RESOLUTION MSC.125(75) (adopted on 24 May 2002)

ADOPTION OF AMENDMENTS TO THE GUIDELINES ON THE ENHANCED PROGRAMME OF INSPECTIONS DURING SURVEYS OF BULK CARRIERS AND OIL TANKERS (RESOLUTION A.744(18))

**AMENDMENTS TO THE GUIDELINES ON THE ENHANCED PROGRAMME OF
INSPECTIONS DURING SURVEYS OF BULK CARRIERS AND OIL TANKERS
(RESOLUTION A.744(18), AS AMENDED)**

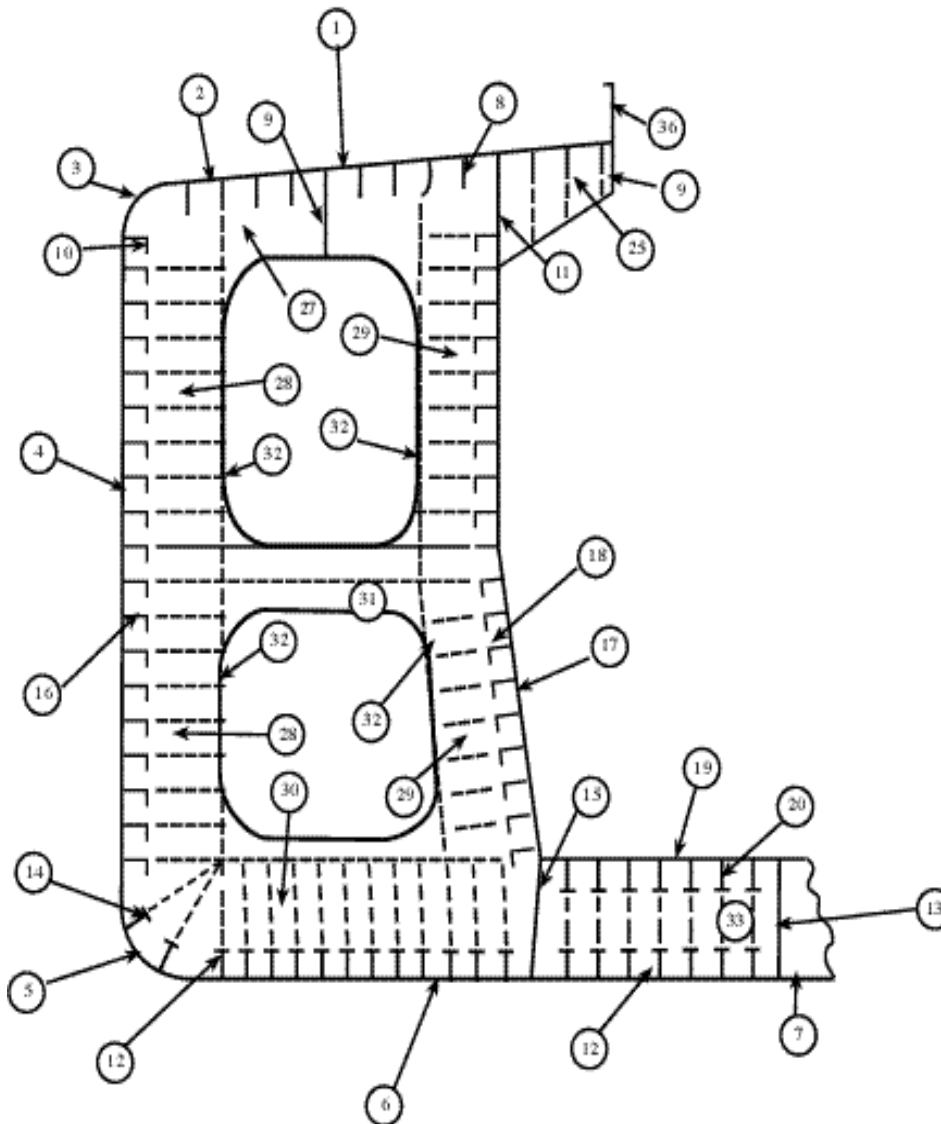
.1 The existing text of the heading of the first column is replaced by the following:

"Position of substantially corroded tanks/areas or areas with deep pitting"

Thickness measurement and close-up survey requirements

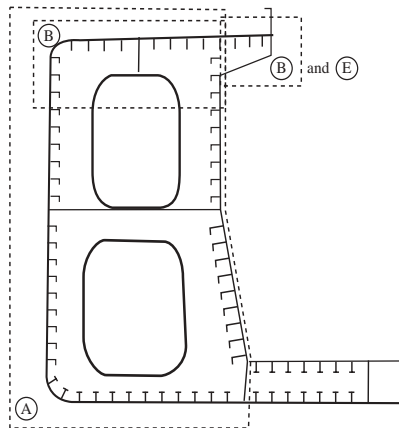
Typical transverse section close-up survey

Thickness to be reported on
TM3-T of Annex B and TM4-T of Annex B
as appropriate

Typical transverse bulkhead

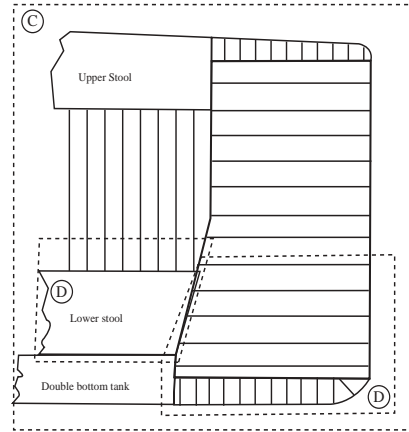
Thickness to be reported on TM5-T of Annex B

Recommendations for the extent and pattern of gaugings
are indicated in Annex 10.

Figure 1. Ships without lower stool

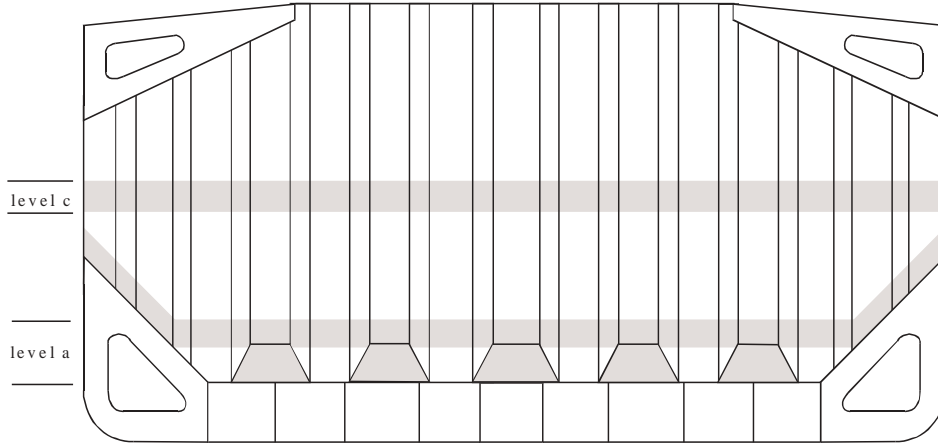
Level (a) Ships without lower stool (see figure 1):

- The mid-breadth of the corrugation flanges at approximately 200 mm above the line of shedder plates;
- The middle of gusset plates between corrugation flanges, where fitted;
- The middle of the shedder plates;
- The mid-breadth of the corrugation webs at approximately 200 mm above the line of shedder plates.

Figure 2. Ships with lower stool

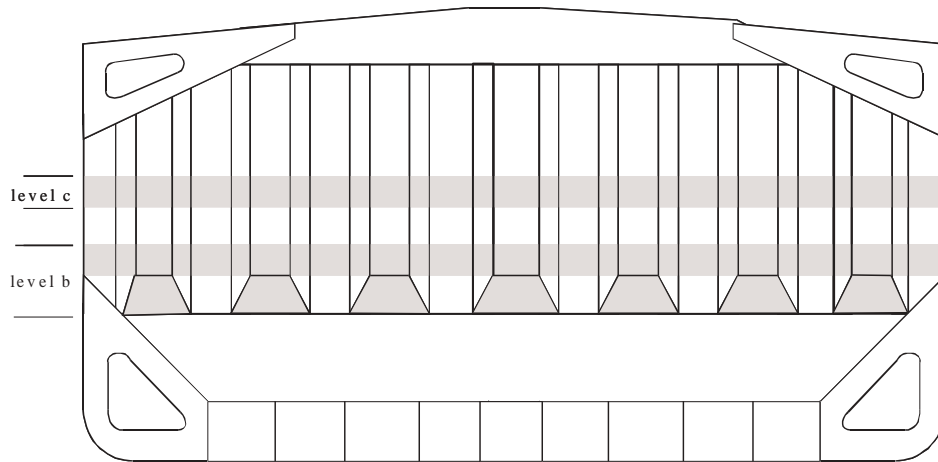
Level (b) Ships with lower stool (see figure 2):

- The mid-breadth of the corrugation flanges at approximately 200 mm above the line of shedder plates;
- The middle of gusset plates between corrugation flanges, where fitted;
- The middle of the shedder plates;
- The mid-breadth of the corrugation webs at approximately 200 mm above the line of shedder plates.
